Rezoning Transportation Analysis

Petition Number: 2018-073

Date	Description
07-25-2018	First Review
06-17-2019	Second Review

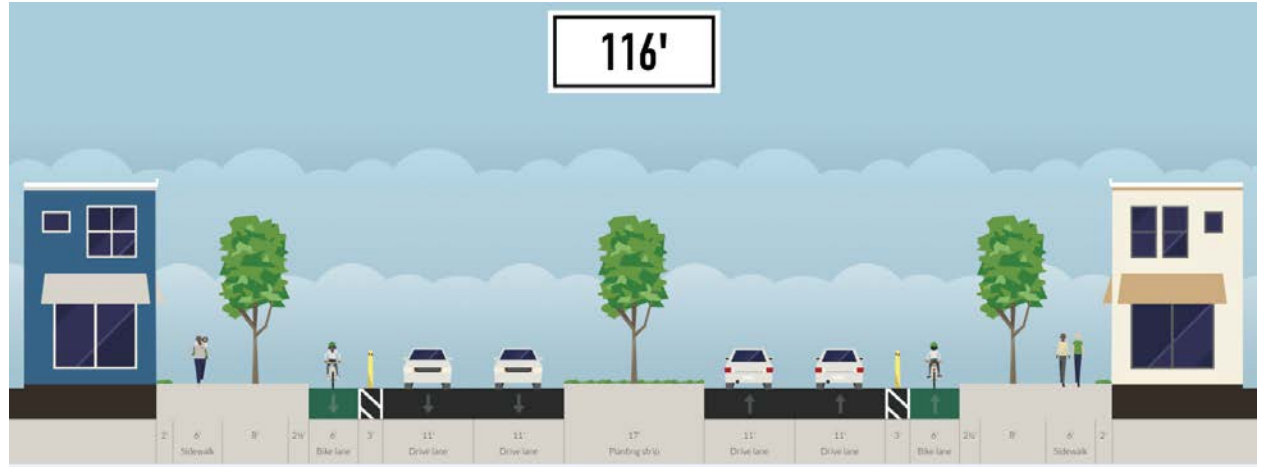
- a. Moores Chapel Rd. is designated as a 4-lane divided minor thoroughfare with buffed bike lanes; therefore its future back of curb is 42' as measured from its proposed centerline (see below typical section).
